UNITED STATES PATENT AND TRADEMARK OFFICE

APPLICATION NO.	FILING DATE	FIRST NAMED INVENTOR	ATTORNEY DOCKET NO.	CONFIRMATION NO.
10/790,392	03/01/2004	William L. Grilliot	MOR3334P1071US	2675
32116	7590	01/25/2005	EXAMINER	
WOOD, PHILLIPS, KATZ, CLARK & MORTIMER 500 W. MADISON STREET SUITE 3800 CHICAGO, IL 60661			WELCH, GARY L	
			ART UNIT	PAPER NUMBER
			3765

Office Action Summary

Fig. 4

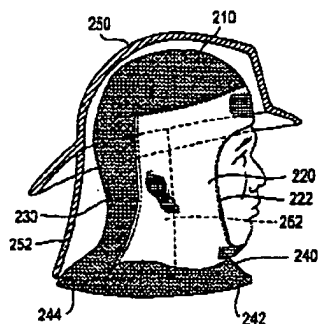
Figure 4 of Lewis et al. shows the garment 200 worn in combination with a firefighter's helmet 250. Therefore, since the wearer's head is protected with a helmet 250, the top portion of the garment 200 is manufactured from same material as the back

portion 230. However, it would have been obvious to one of ordinary skill in the art at the time the invention was made to increase the wearer's protection by increasing the coverage of the fluid impervious, heat reflective layer nearer the top of the garment 200.

With regard to claim 2, the heat reflective layer is continuous from a region at or near one side of the front portion 220 to a region at or near the other side of the front portion 220 (see Figure 4 where layer extends from right side seam, across face to left side seam).
